RE: Submission to Western Sydney Aerotropolis Draft LUIP, Stage 1: Initial Precincts

I represent BTF Holding Pty.Ltd who owns land at 50 Kelvin Park Drive, Bringelly. The site has a total area of 20,000m². According to the LUIIP, this land has been provided with indicative zoning comprising two zoning types (Figure 1), as follows:

Flood planning area map - sheet FLD-006

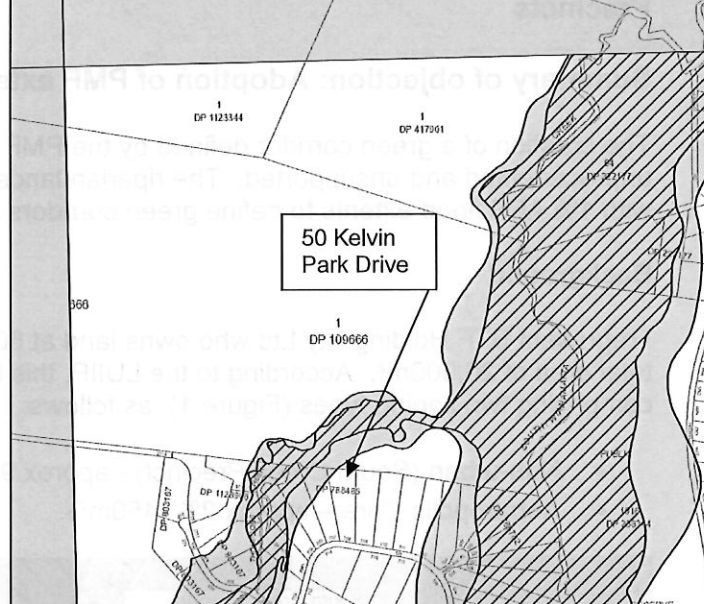
The non-hatched green area (equating roughly to a PMF extent) provides only a marginally increased area of land for green corridor, while also sterilising many lots from development. The benefit derived by way of a slightly larger green corridor does not appear to justify the amount of otherwise developable land that would be sterilized as a result.

Figure 3: Flood risk at Bringelly

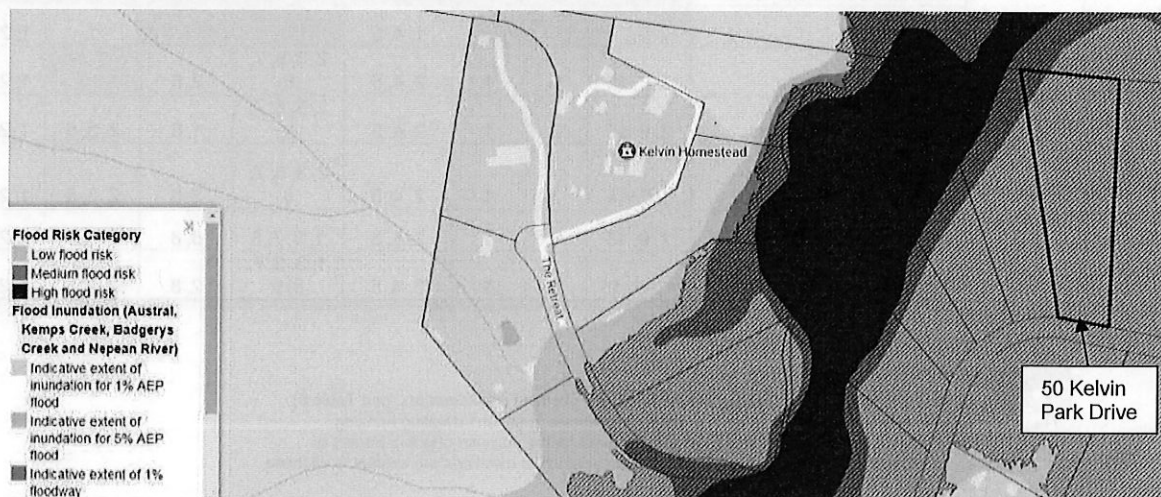
For point ii. it refers to the *Liverpool DCP 2008* for details. Liverpool City Council has characterised the flood risk of the site (Figure 4) as follows:

- 98% Low Flood Risk
- 2% Medium Flood Risk

Table 2 indicates that various land uses are applicable, subject to them demonstrating compliance with specific flood-related criteria. Typically, Table 6 in Council's DCP Chapter on Flood Risk lists flood criteria for Low Flood Risk land as habitable floor levels which range from the 20% AEP to the 1% AEP flood plus 500mm freeboard.

Council's existing development controls for flooding (as stated above) appear to strike a balanced outcome of development coupled with flood protection. They represent the norm as applied in New South Wales. They allow for a range of developments to occur on the land, subject to meeting various flood planning criteria.

Figure 4: 40m VRZ and its minor effect on the property at 50 Kelvin Park Drive

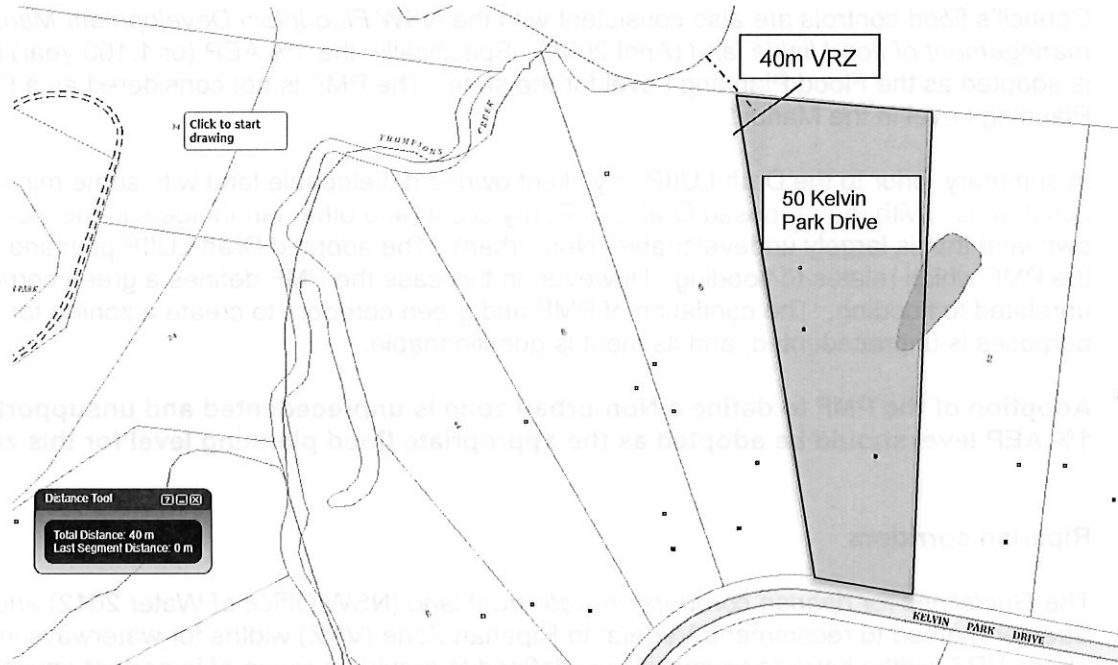
The maximum VRZ width in the Guidelines is for 4th order waterways (rivers) and is 40m wide. Thompsons Creek (to the immediate north of the site) is a 2nd order waterway, requiring only a 20m wide VRZ. To be conservative, we have applied a maximum 40m wide VRZ to Thompsons Creek (Figure 4). The resulting VRZ affects a very small portion of the north-western corner of the site.

A fully functioning green corridor (Non-urban zone) can be created adjoining the site by applying the riparian Guidelines.
